Subject: NOISE FROM MAP LIGHT WHILE DRIVING	Bulletin No: 09-034/12
	Last Issued: 12/19/2012

- This bulletin supersedes the previous bulletins 09-034/12 issued 08/22/12, 09-006/11 issued on 02/07/11, and 09-071/09 issued on 11/12/09. The APPLICABLE MODEL(S)/VINS, REPAIR PROCEDURE, PARTS INFORMATION, and WARRANTY have been revised.
- Changes are noted below beside the change bar in Red.

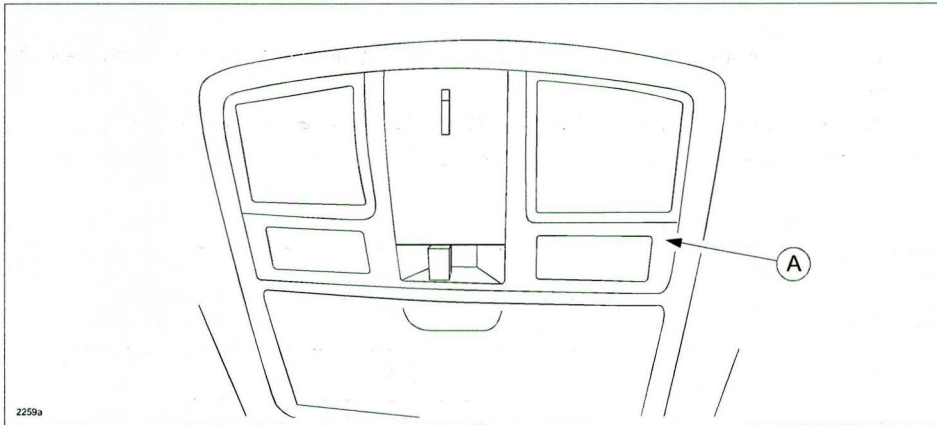
Some vehicles may exhibit a noise from the map light (A) while driving or at idle. This is caused by one of two things.

1. Excessive clearance between the map light and lamp unit positioning rib (for Mazda3 vehicles with VINs lower than JM1BL*****144839 / produced before April 1, 2009). The design of this rib has now been changed to correct this problem.
2. The overhead console bracket vibrates and contacts the roof panel (for Mazda3 vehicles with VINs JM1BL*****144839 to JM1BL*****707082 / produced after April 1, 2009 and before August 8, 2012). The noise occurs on vehicles that have a non-woven textile attached at the front stay. The material of the pads has now been changed to correct this problem.
